Hampton Inn Hotel (former Jordan's Site)

TO: Jeanie Bourke, Building Inspections
FROM: Bill Needelman, Senior Planner
DATE: May 28, 2010
RE: Opechee Request for Foundation-Only Building Permit at 207-209 Fore Street (former Jordan's Meats site)
CBL: 029-L-001,002,003
Appl. ID: 99700001

The following review comments are offered by the Planning Staff after reviewing the preliminary design of a hotel, restaurant and residential development proposed by Opechee Construction Corp. for the former Jordan's Meats site at 207 to 209 Fore Street.

HOTEL, RESIDENCES, AND RESTAURANT
207-209 FORE STREET (FORMER JORDAN'S MEATS SITE)
MAJOR SITE PLAN, SUBDIVISION, AND MDOT TRAFFIC MOVEMENT PERMIT
PROJECT ID #99700001
OLD PORT HOSPITALITY, LLC., OPECHEE CONSTRUCTION, APPLICANT

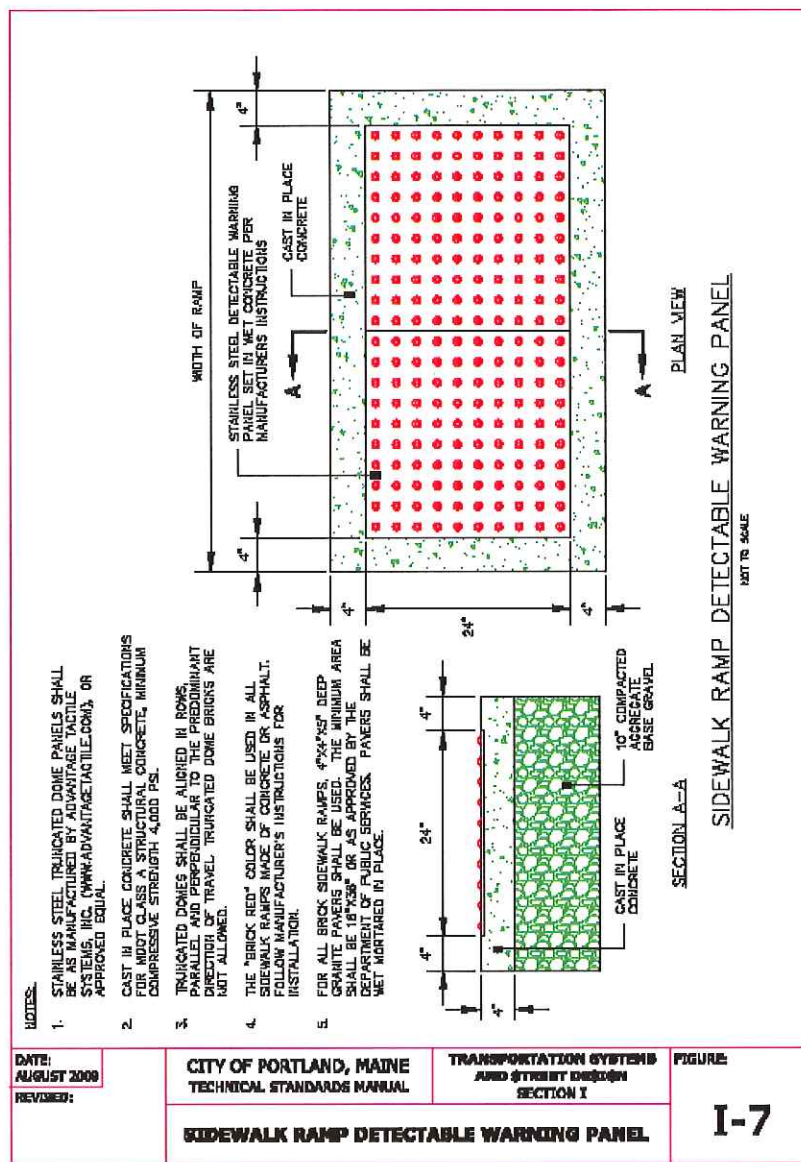
14. This department is still reviewing lighting standards for this project, i.e. light pole spacing and power feed requirements with CMP.

No response necessary.
